Title: A/C Condensers for LT and RH Part Number Update

Applies To: LT and RH

This document will show the user the difference between original production and new A/C Condensers for LT and RH vehicles.

Condenser P/N 2516098C91 has been replaced with P/N 2518753C91, see images below:

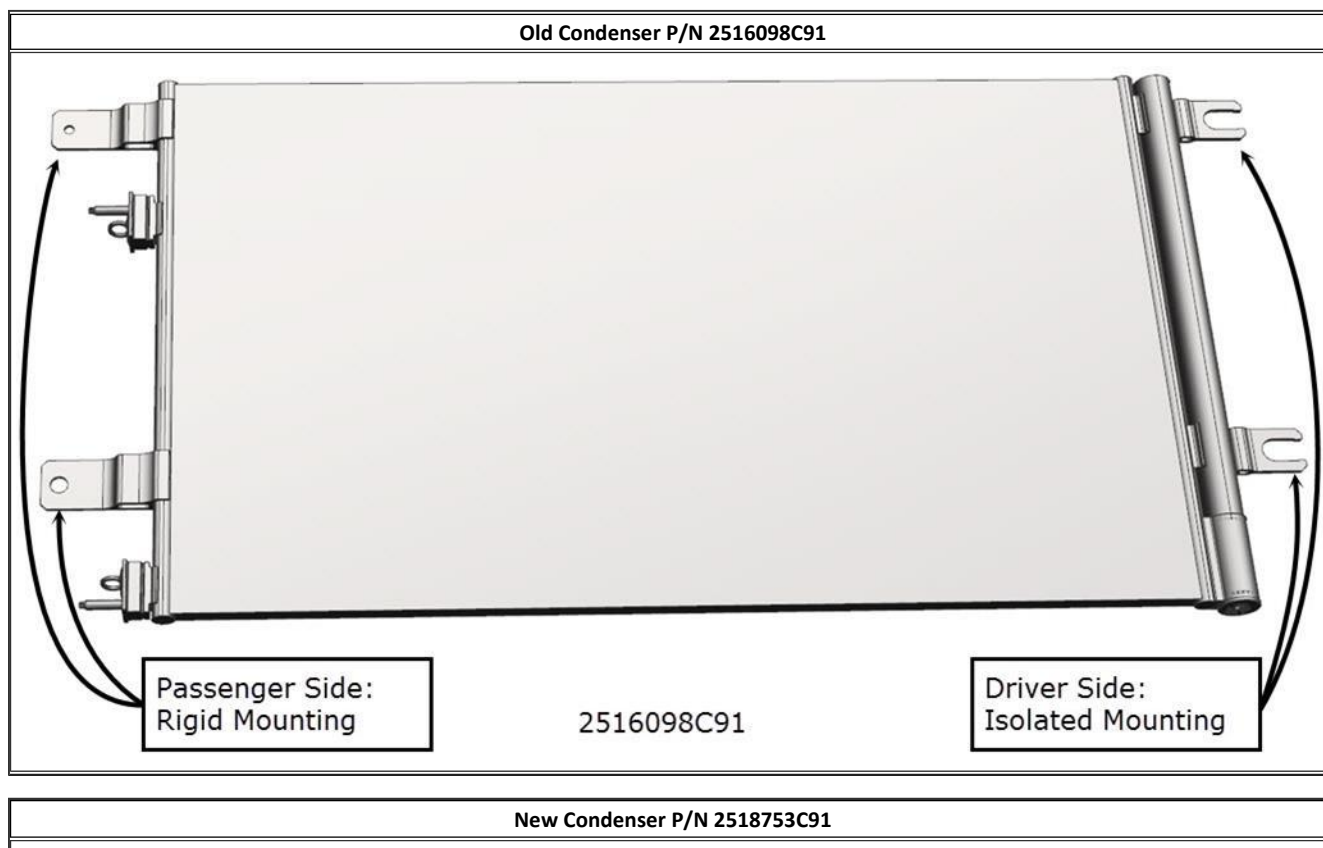
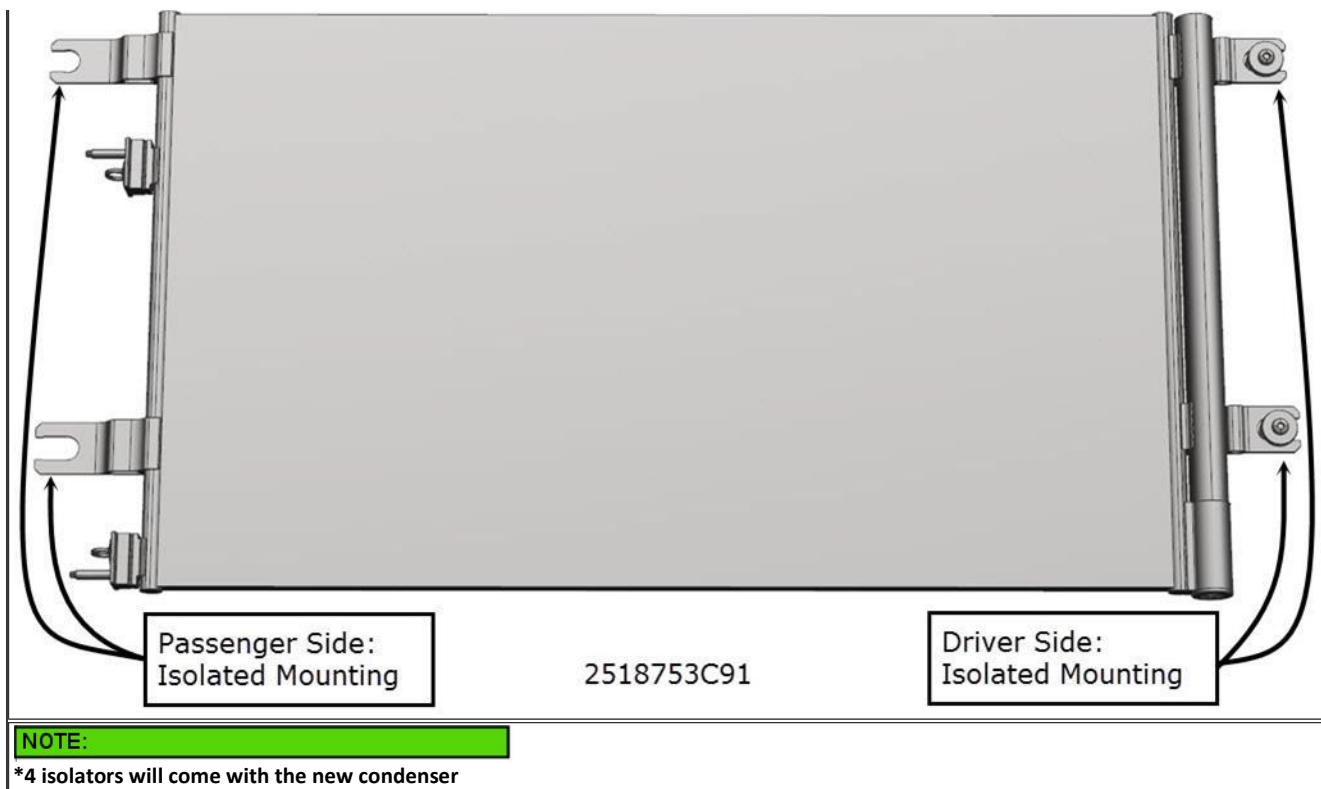
NOTE:
The New Condenser can also be identified by the number of microchannels in the tubes

Original Condenser - 18 Microchannels

- A small number of production vehicles had 4 isolators with the 18 Microchannel design (Built between 10/17/2017 and 11/08/2017)
- 4 Isolators with 18 Microchannels was never available as a service part

New Condenser 2518753C91 - 8 Microchannels**NOTE:**

The New Condenser 2518753C91 is the only available service part
